Access Compliance Report

Public Rights-of-Way

Intersection ID: 10034403	Main Street: PIEDMONT_ROW_DR_SOUTH	Cross Street: N/A	Location: SW
ADA ID: 237312B6A97C	Ramp Type: BlendTrans2	Initial Pass/Fail: Pass	Overall Compliance: No
Severity Score: 2.75			
Codes/Mitigation Info/Possible Solution		Field Measurements/Component Compliance

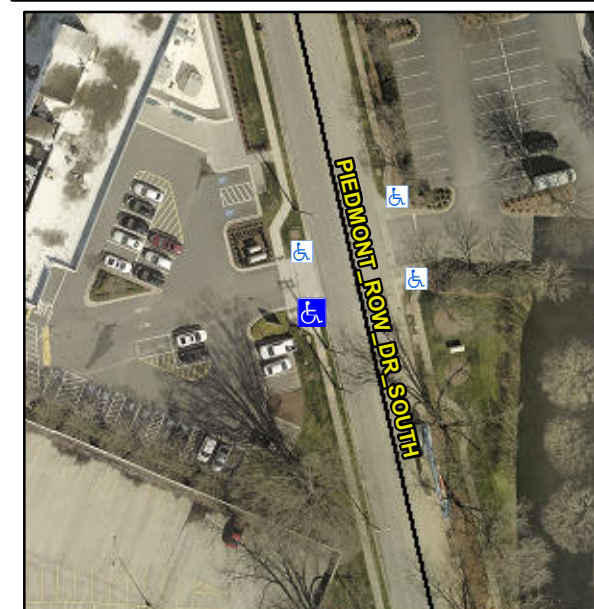
R304.5.3, R305.1.4, R305.2

Compliance	Description	Data	Compliance	Description	Data
N/A	Ramp Length (in)	48.0	Yes	BlendTrans Slope (%)	2.2
Yes	Ramp Width (in)	60.0	No	BlendTrans XSlope (%)	2.4
N/A	Flare Type LT	None	N/A	Flare Type RT	None
N/A	Flare Slope LT (%)	N/A	N/A	Flare Slope RT (%)	N/A
N/A	Flare Traversable LT?	N/A	N/A	Flare Traversable RT?	N/A
N/A	Landing Length (in)	N/A	Yes	DWS Provided?	Yes
N/A	Landing Width (in)	N/A	Yes	DWS Contrast?	Yes
N/A	Landing Slope (%)	N/A	Yes	DWS Length (in)	24.0
N/A	Landing X Slope (%)	N/A	No	DWS Full Width?	No
N/A	Landing Curb? (Y/N)	No	No	DWS Offset (in)	3.5
N/A	Shared Landing?	No			
Yes	Gutter Ponding?	No	Yes	Gutter Slope (%)	3.4
Yes	Gutter Lip Ht (in)	0.0	Yes	Gutter X Slope (%)	1.8
N/A	Painted X Walk1?	No	N/A	Painted X Walk2?	N/A
	X Walk 1 Direction	To NW		X Walk 2 Direction	N/A
	X Walk 1 Width (in)	N/A		X Walk 2 Width (in)	N/A
	X Walk 1 Slope (%)	1.5		X Walk 2 Slope (%)	N/A
	X Walk 1 X Slope (%)	0.9		X Walk 2 X Slope (%)	N/A

Remove & Replace Curb Ramp With Two New Directional Ramps or Equivalent.
